Re: Maine RSA #4, Inc. d/b/a U.S. Cellular Corporation (USCC) – Telecommunication Facility

The revised Application information is provided to address the proposed reduction of tower height for the telecommunications facility on the property owned by Christopher Cochran and located off of West Street in the Big Lake Township, Washington County, identified as Lot 25 on Map 04. USCC has performed improved Radio Frequency (RF) propagation studies on the proposed Big Lake Township area and have determined that a tower height of 190' instead of the originally proposed 250' tower height is sufficient to provide RF coverage in the area that meets the USCC coverage needs and the FCC Auction 901 coverage requirements which USCC desires to meet.

Application
For
Wireless Telecommunication Site Plan
To Construct a 190' Telecommunication Facility

TOWER ELEVATION AND ANTENNA LOCATION SECTION

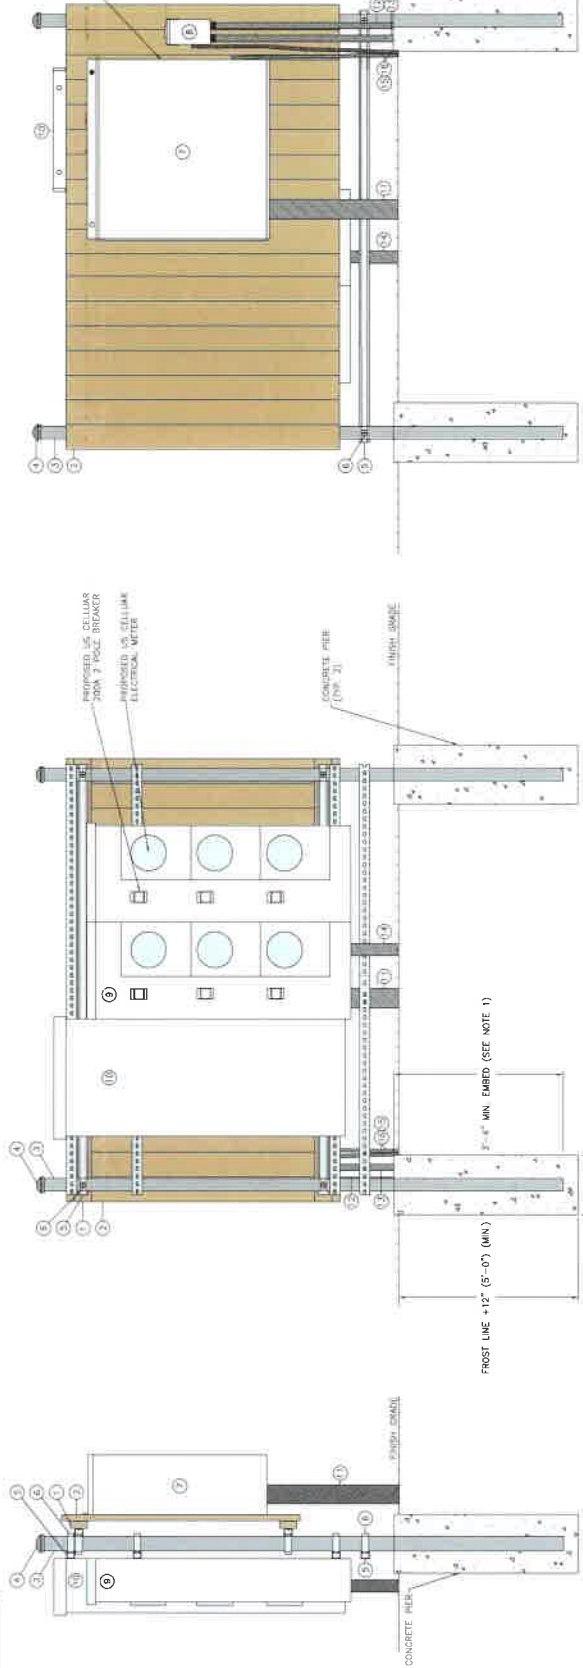
As such, the replacement pages provided to the original Application reflect the changes to the Application to address this change in tower height. In addition, the Site Plan engineering drawings have been revised to address the change in tower height. Drawing USCC-119_ARC-1A-2 has additionally been revised to include the installation of the Remote Radio Units (RRUs) and a Raycap SPD to the tower. The installation of these devices provides for improved RF propagation from the antennas by reducing the signal losses from the previous COAX cables for LTE transmission and reduces tower profile along the length of the tower.

MAP 5 - PREDICTIVE VIEWSHED MAP 190' TOWER
Visual Assessment of USCC-119
Big Lake, No. 21 Township, Maine

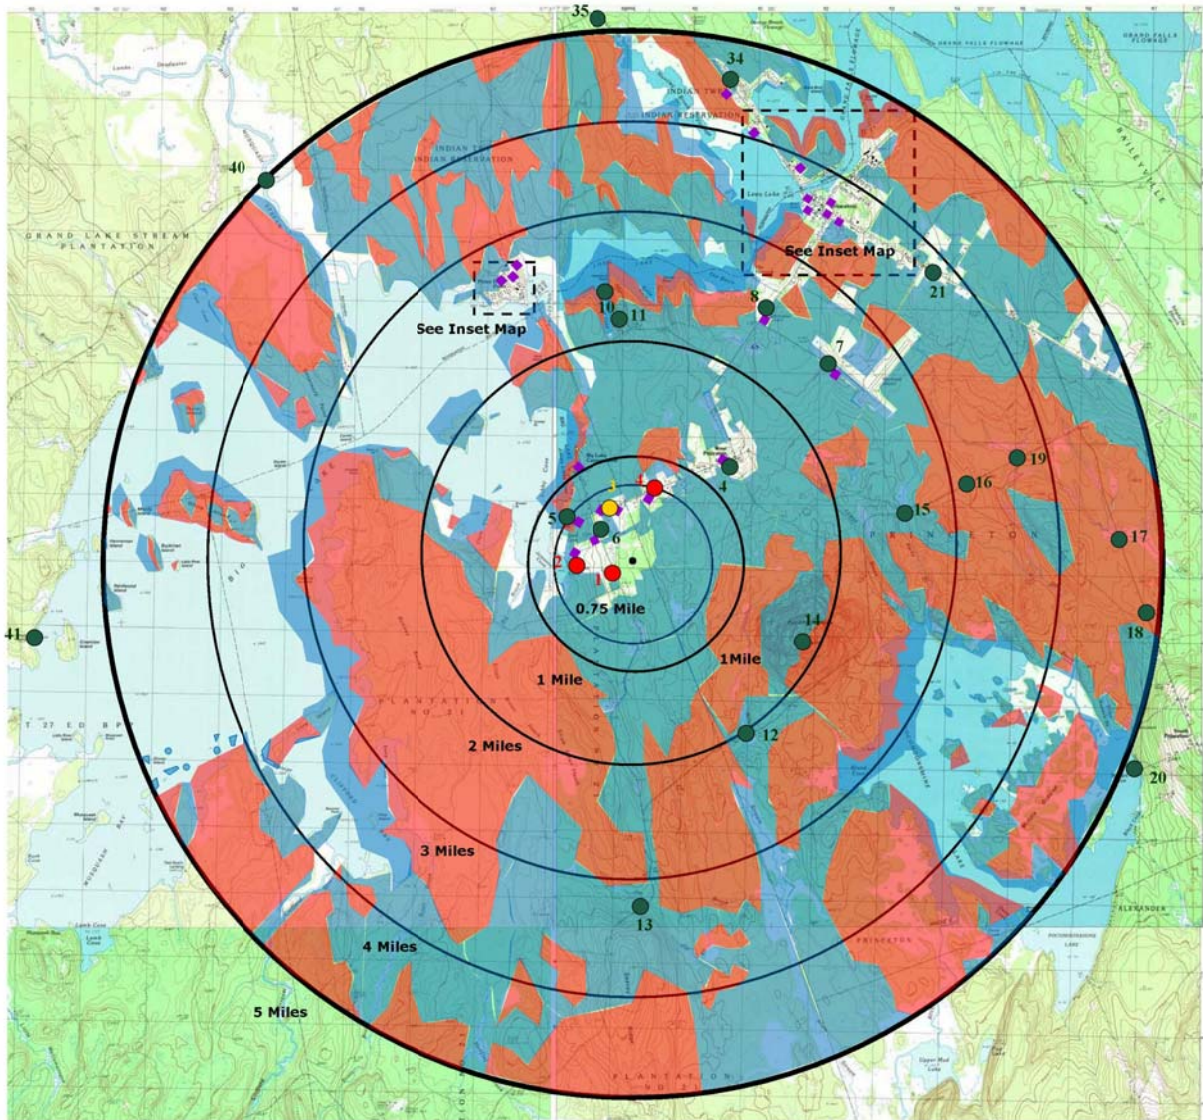
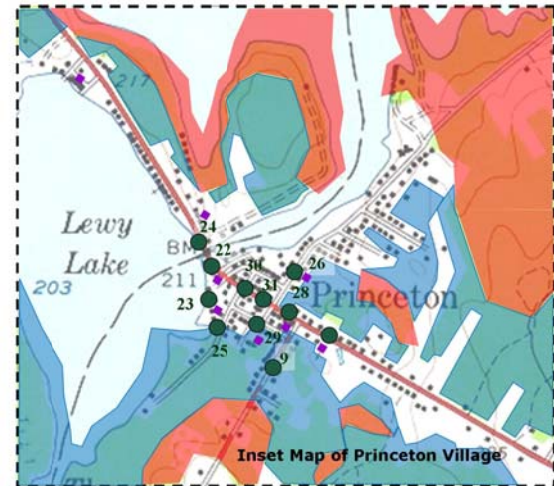
Karen, I have received a revised Predictive Viewshed Map 5 for the 190' tower from ttl-Architect. The only change to the viewshed map is that it now also provides the photo references on the map as previously provided for the predictive viewshed map for the 250' tower. For the (4) referenced photos where the 250' lofted balloon was visible, please bear in mind that the height of the visible balloon would be reduced by 60' for the proposed 190' tower. Thanks, Jim
